Re: Contract N62470-07-D-0502
IQC for A/E Services for Multi-Media
Environmental Compliance Engineering Support
Delivery Order (DO) 0002
U.S. Naval Activity Puerto Rico (NAPR)
EPA I.D. No. PR2170027203
Draft Full RCRA Facility Investigation Report for SWMU 9 – Area B, Tank 214 Area
Response to Comments and Proposal for Additional Sampling

NAVY RESPONSES TO PREQB COMMENTS RECEIVED DECEMBER 23, 2009

**PREQB COMMENTS ON THE PROPOSAL FOR ADDITIONAL SAMPLING AND THE
NAVY RESPONSE TO PREQB COMMENTS DATED NOVEMBER 19, 2009
DRAFT FULL RCRA FACILITY INVESTIGATION REPORT FOR
SWMU 9 (AREA B, TANK 214 AREA)**

FIGURE 1
PROPOSED AND PREVIOUS GROUNDWATER AND SUBSURFACE SOIL SAMPLE LOCATION MAP
SWMU 9-AREA B, TANK 214 AREA
FULL RFI REPORT
NAVAL ACTIVITY PUERTO RICO

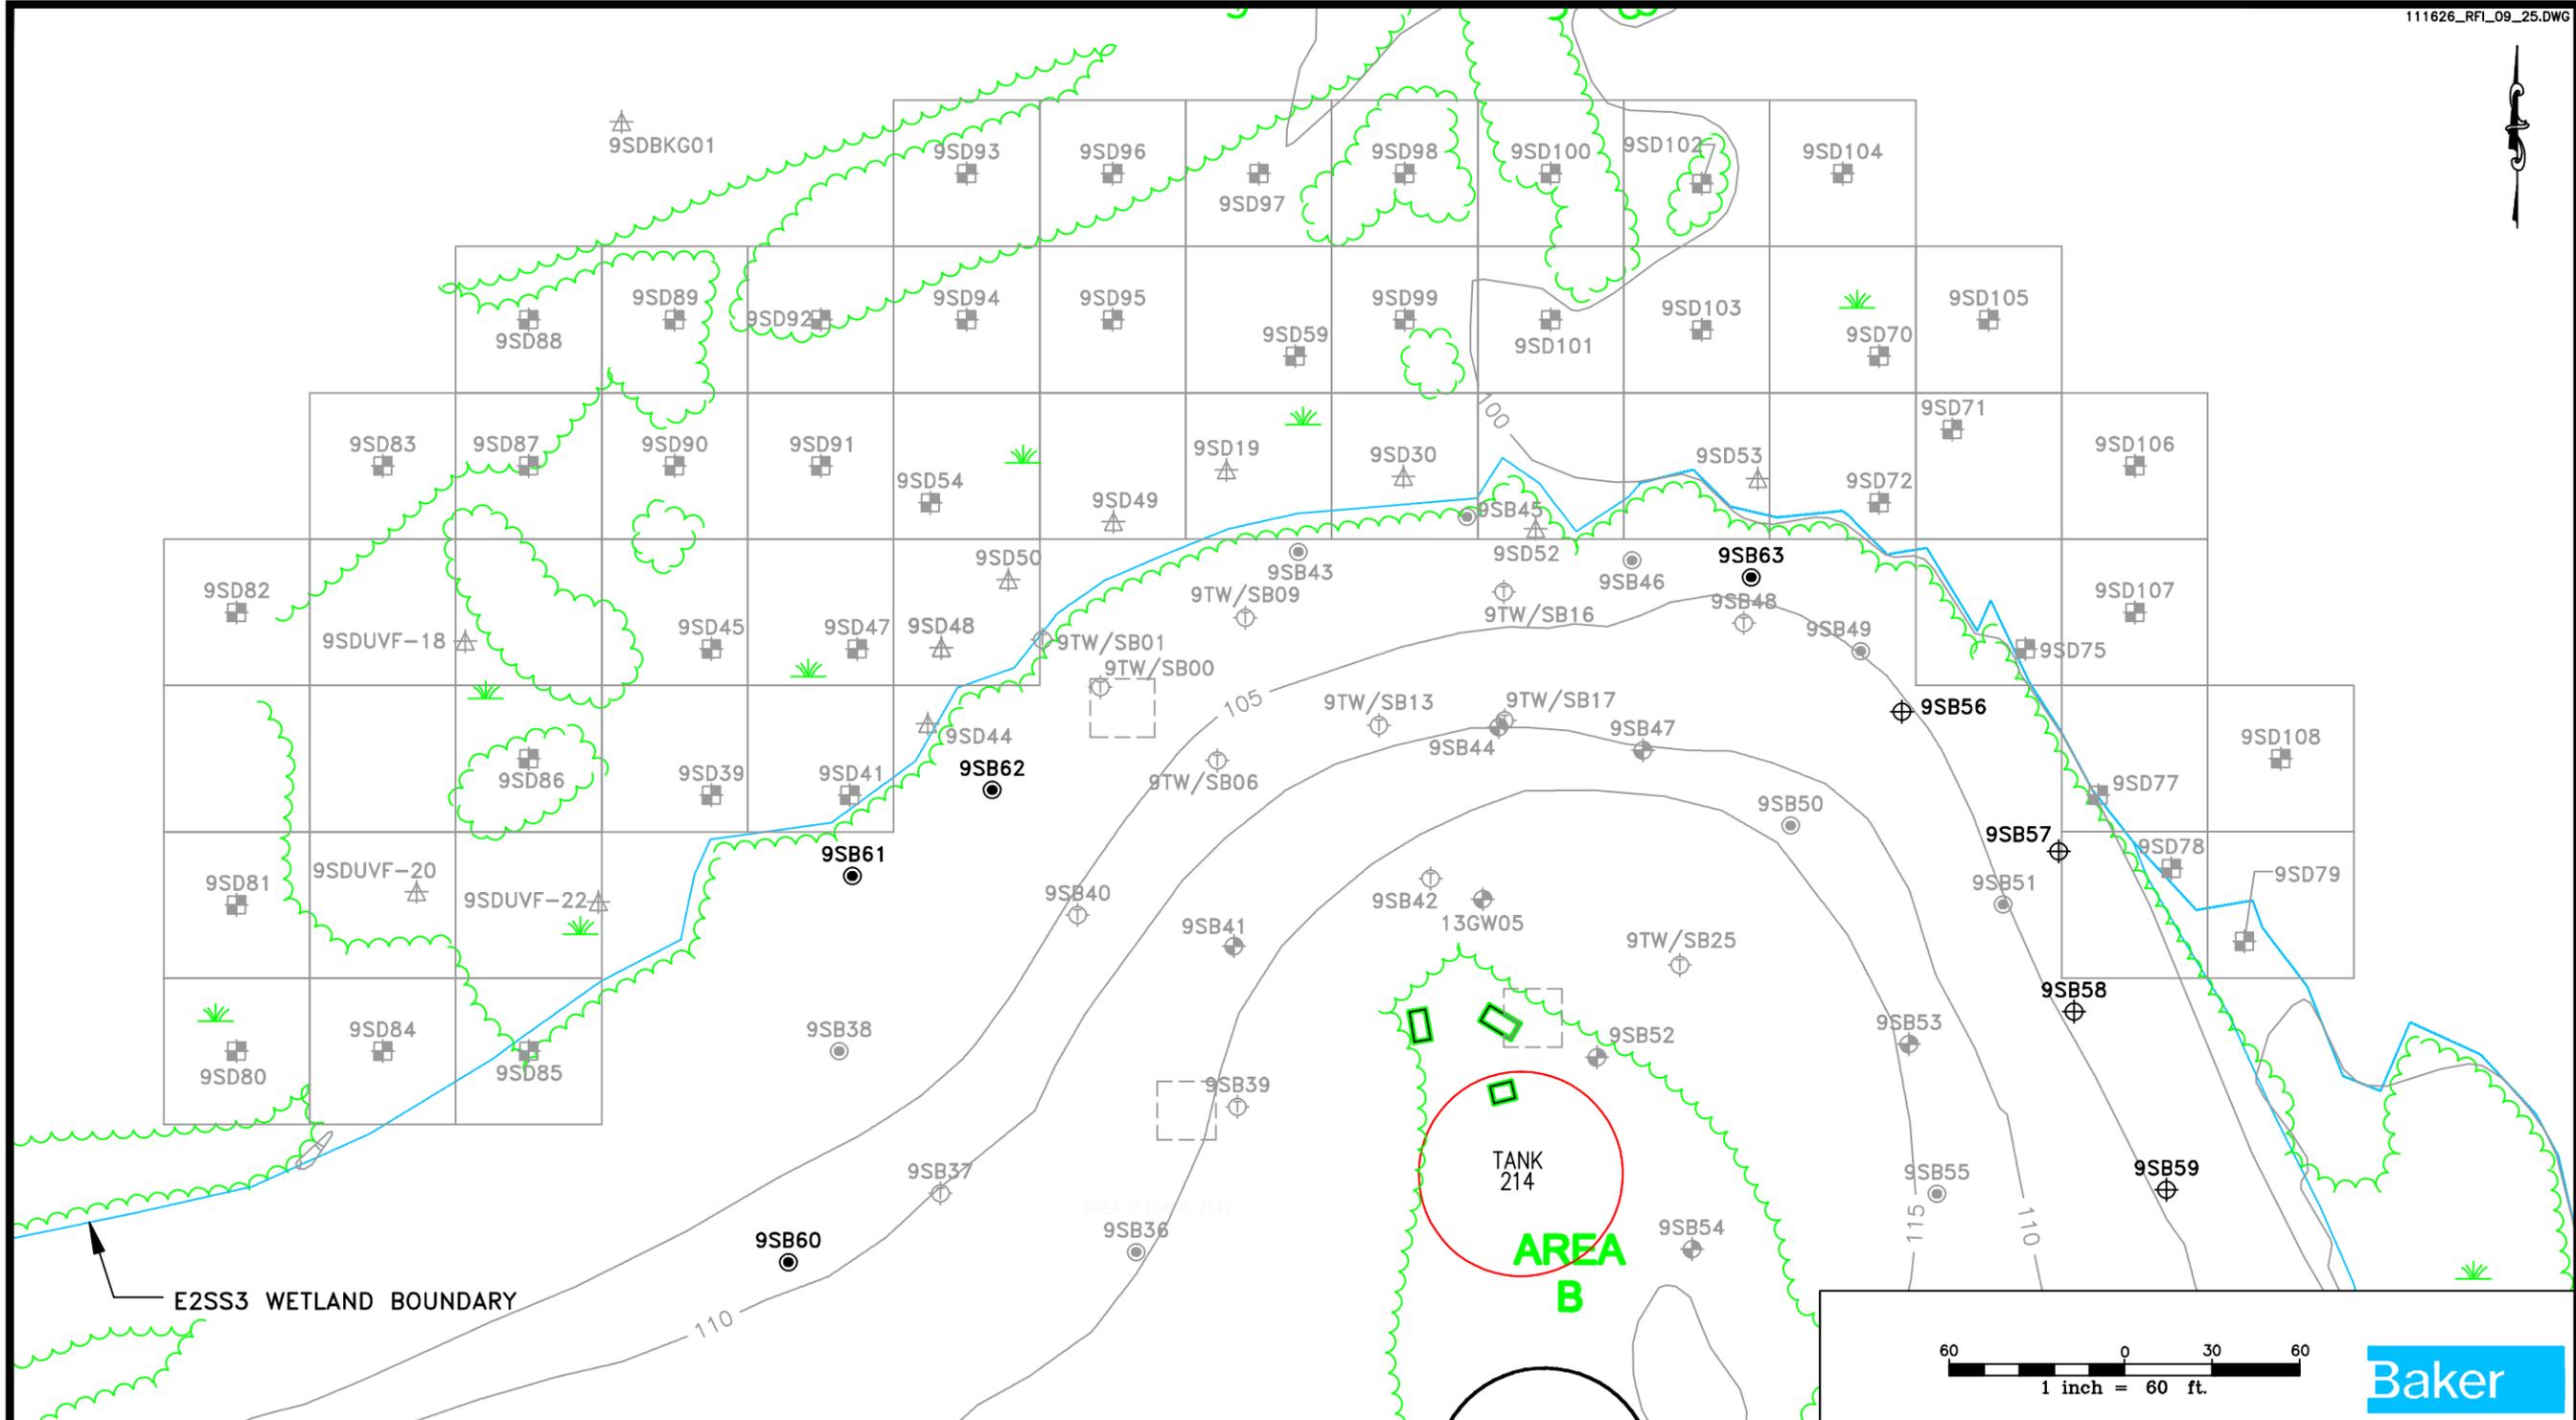
- A total of eight soil borings are proposed east and west of Tank 214, as shown on Figure 1 to further delineate subsurface soil contamination. Note that the location of the borings may be adjusted in the field, as needed to allow for better characterization of potential migration pathways (i.e. topographic low areas or swales, proximity to the estuarine wetland, etc.). The depth interval from which the sample will be collected will be established in the field. Each sample will be analyzed for Appendix IX volatile organic compounds (VOCs) and total petroleum hydrocarbon (TPH) diesel range organics (DRO)/gasoline range organics (GRO).

- Groundwater monitoring wells are proposed for installation in four of the eight borings, as shown on Figure 1. Groundwater samples will be collected from each of the four newly installed wells. Groundwater samples will be analyzed for Appendix IX VOCs and TPH DRO/GRO. Top of casing elevations will be determined for each newly installed well. Additionally, although not specified in the response to comments, groundwater samples will also be collected from existing wells, including five temporary wells installed during the Full RFI (9SB37, 9SB39, 9SB40, 9SB42, and 9SB48), and analyzed for the same parameters above to provide a comprehensive data set.

FIGURE 2
PROPOSED AND PREVIOUS SEDIMENT SAMPLE
LOCATION MAP
SWMU 9-AREA B, TANK 214 AREA
FULL RFI REPORT
NAVAL ACTIVITY PUERTO RICO

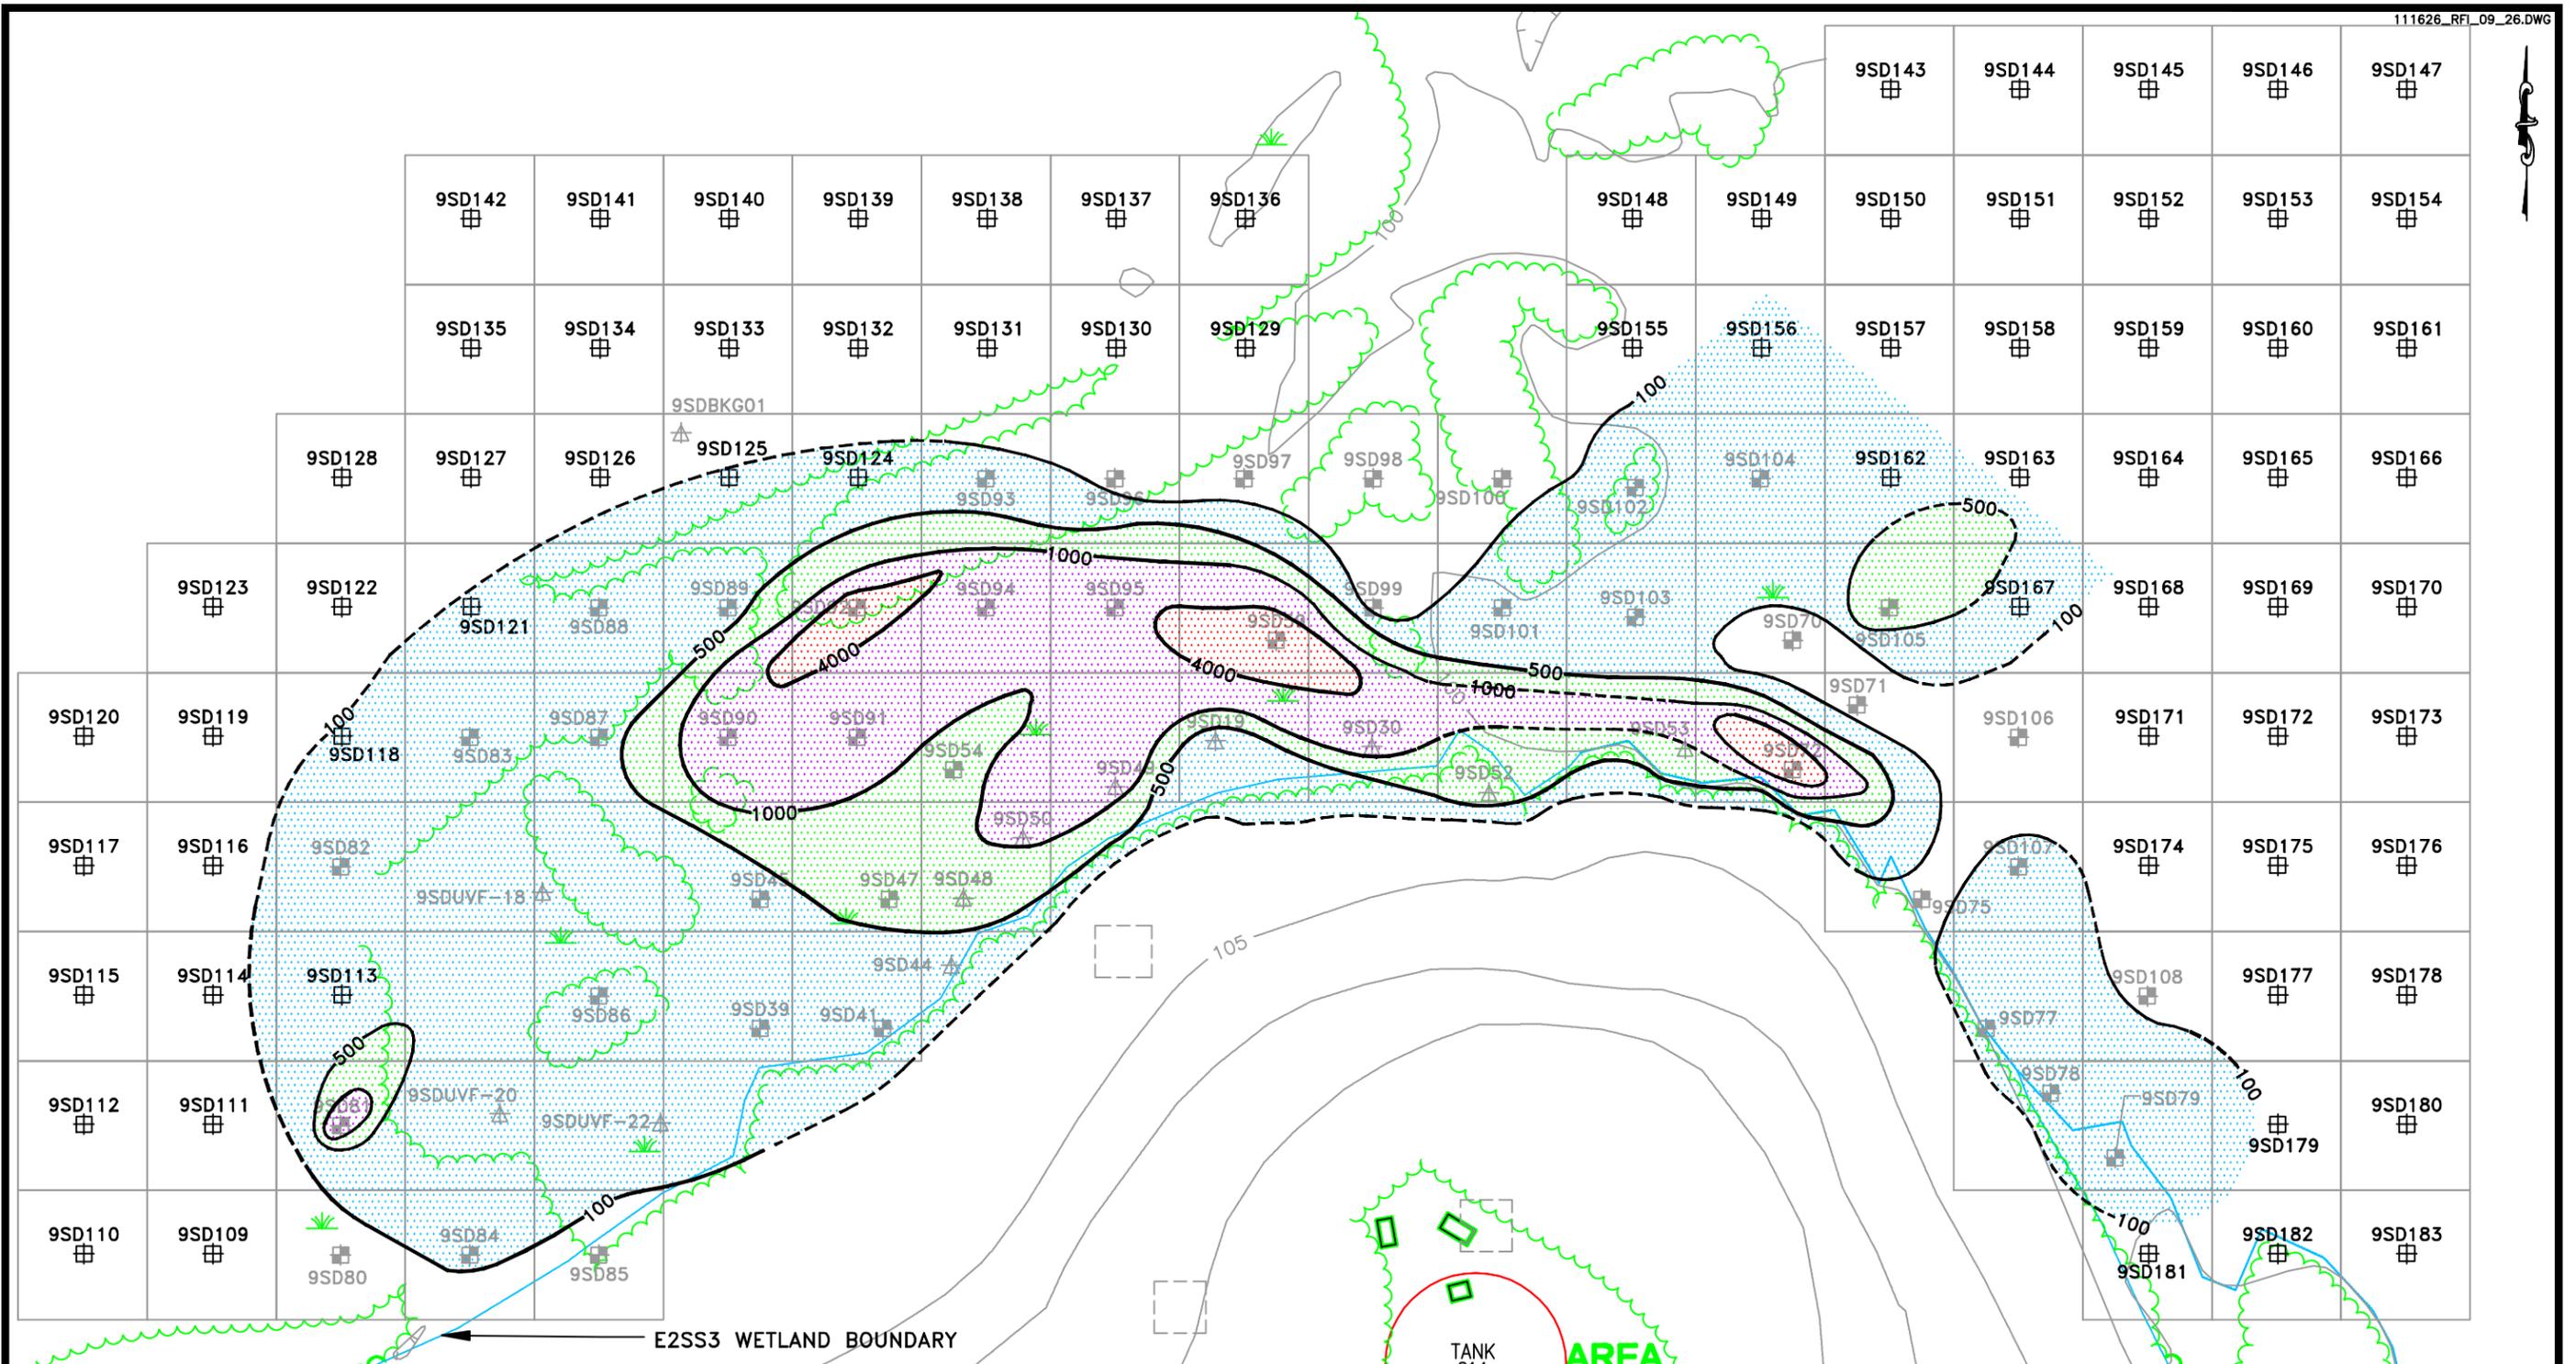
- A total of 75 sediment samples will be collected from the estuarine wetland area from a depth of 0 to 0.50 ft bgs (see Figure 2). The sediment samples will be analyzed for TPH DRO. Sediment samples 9SD129 through 9SD131 and 9SD136 through 9SD138 will be additionally analyzed for vanadium to address the lack of delineation data gap recommended in the Full RFI. In addition, sediment samples 9SD177 through 9SD183 will be analyzed for lead due to an elevated lead detection from the CMS investigation, while sediment samples 9SD09 through 9SD12 will be analyzed for lead due to contamination identified in the Full RFI Report. Finally, sediment samples 9SD124 and 9SD125 will be analyzed for PAHs to delineate contamination at Full RFI sample location 9SD92.

- 2. The last sentence in the third bullet on page 2 describes the proposed sediment sampling for lead to better understand findings from the CMS investigation. The text indicates samples 9SD177 through 9SD181 will be analyzed for lead. Please add two samples to analyze sample locations 9SD182 and 9SD183. Figure 6-8 of the RFI indicates the southeastern corner of the elevated lead extends into the location occupied by 9SD182, so lead analysis of 9SD182 is needed. Lead analysis of 9SD183 is also suggested to ensure that the lateral extent of lead contamination has been determined. Note that sample 9SD183 will already be collected for TPH DRO analysis, so the only cost is the additional single lead analysis.*

Navy Response: The Navy agrees with this comment. The text within the last bullet item on Page 2 will be revised to indicate that proposed sediment samples 9SD182 and 9SD183 will be analyzed for lead. In addition to these two sediment samples, the text will be revised to indicate that four proposed sediment samples located in the southwestern corner of the study area (i.e., 9SD109, 9SD110, 9SD111, and 9SD112) also will be analyzed for lead. Figure 6-8 of the Full RFI Report indicates that lead contamination may extend into the location occupied by 9SD109. Sediment collected at 9SD109, 9SD110, 9SD111, and 9SD112 will be analyzed for lead to ensure the lateral extent of lead contamination has been established.
